**Re: Swiss Army Brands, Inc.**  
65 Trap Falls Road, Shelton, Connecticut

Per your request, Facility Support Services is sending you the following revisions for the Swiss Army Brands, Inc. facility, 65 Trap Falls Road, Shelton, Connecticut Decommissioning Report:

Figure 3  
Swiss Army Brands, Inc.  
65 Falls Traps Road, Shelton, CT

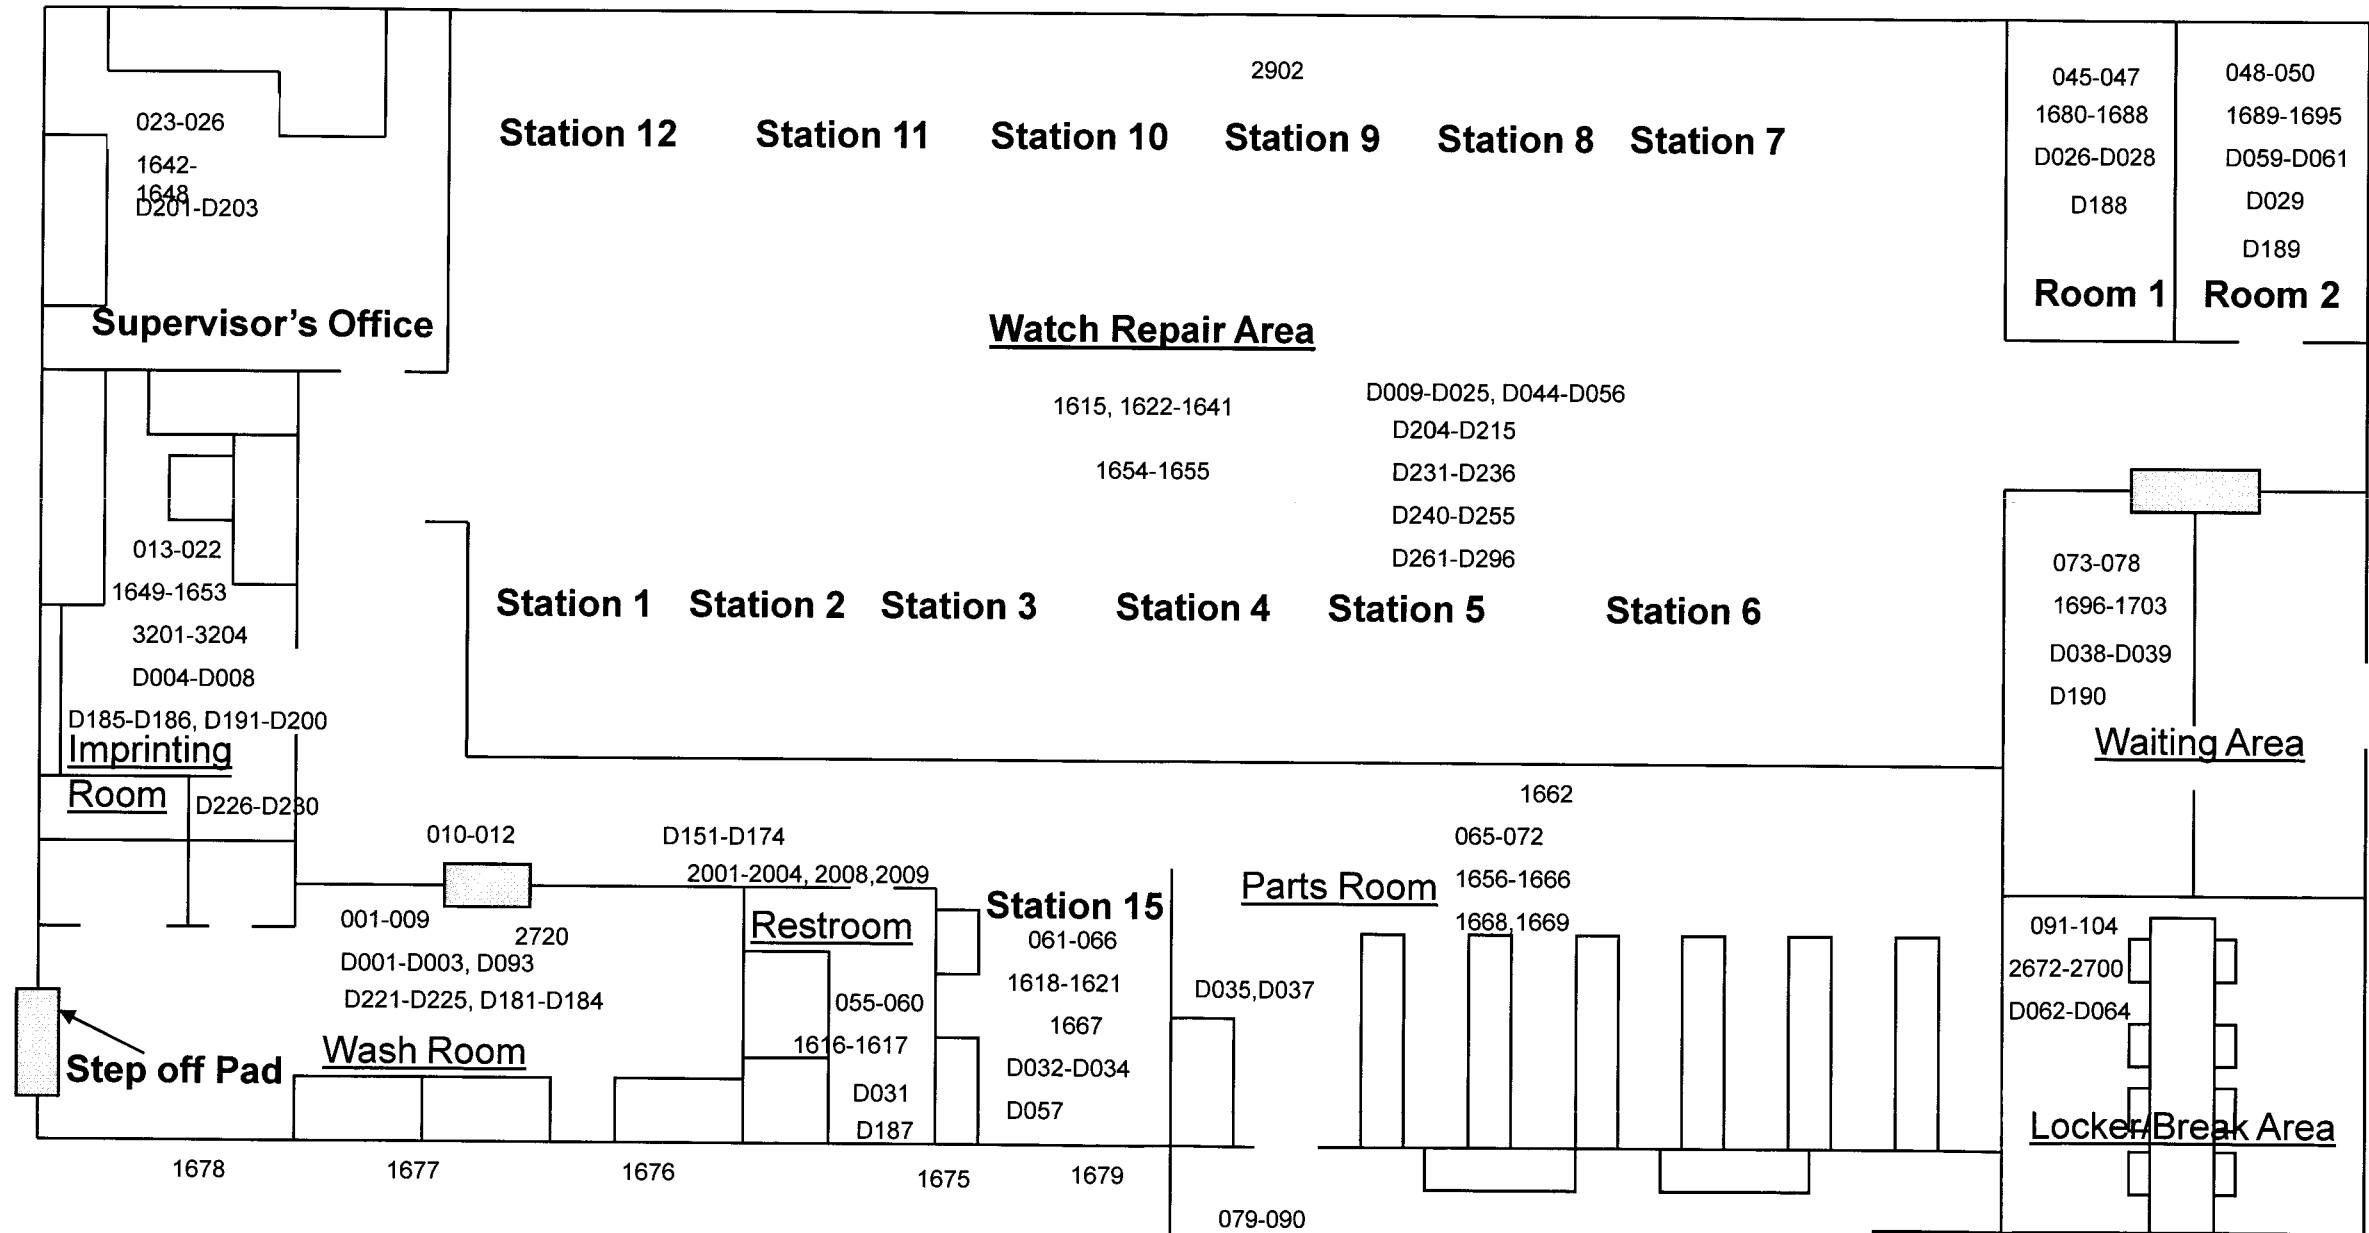
- During the decommissioning of the Swiss Army Brands, Inc. facility, 65 Trap Falls Road, Shelton, Connecticut, the racks and mezzanine areas were deconstructed by a construction contracting company. The construction contracting company deconstructed mezzanine G without approval from Facility Support Services. As a sample located in mezzanine G had high tritium levels, all of the beams and other structures located in this mezzanine were decontaminated. Random wipe sampling was then conducted as post decontamination samples.
- I have reviewed our field sampling location maps and located sample number 2902 in the watch repair room. I have attached a revised Figure 3: Watch Repair Area Sampling Locations to this letter. Sample number 2902 is located above Station 9.
